Tour Edition Motors with 63" Cables

Models Covered
Tour Edition Series with 45 inch or shorter columns and 63 inch foot-pedal steering cables

16861

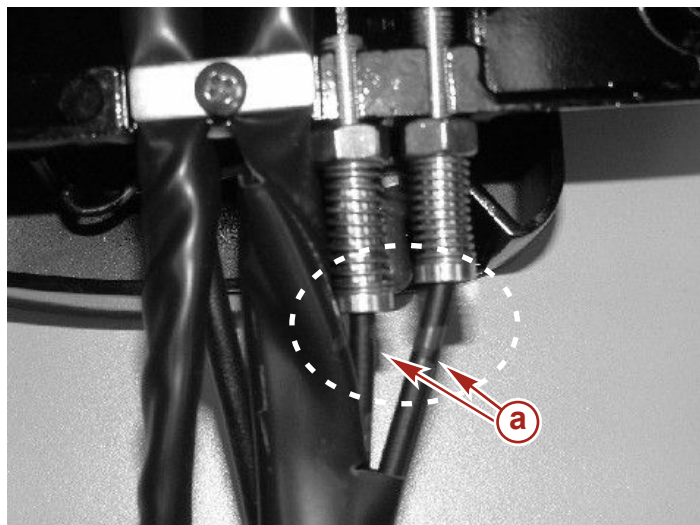
The trolling motors referenced above are impacted by a foot-pedal cable that has the potential for the outer cable shell to collapse causing a soft steering pedal condition.

Replace the two cables that connect the foot-pedal to the motor and control the steering. After the cable issue was identified, part numbers for the improved replacement cables were changed. Additionally, the improved replacement cables have been denoted by the factory with a blue mark which is located near the cable adjustment springs on the base of the foot-pedal (see photo for the blue mark location). If you are servicing one of these Tour Edition models that do not have blue markings on the foot-pedal cables, replace the cables.

a - Blue marks located on cables beneath adjustment springs

Qty.	Description	Part Number
1	Cable Assembly - Short	MPM02753
1	Cable Assembly - Long	MPM02754
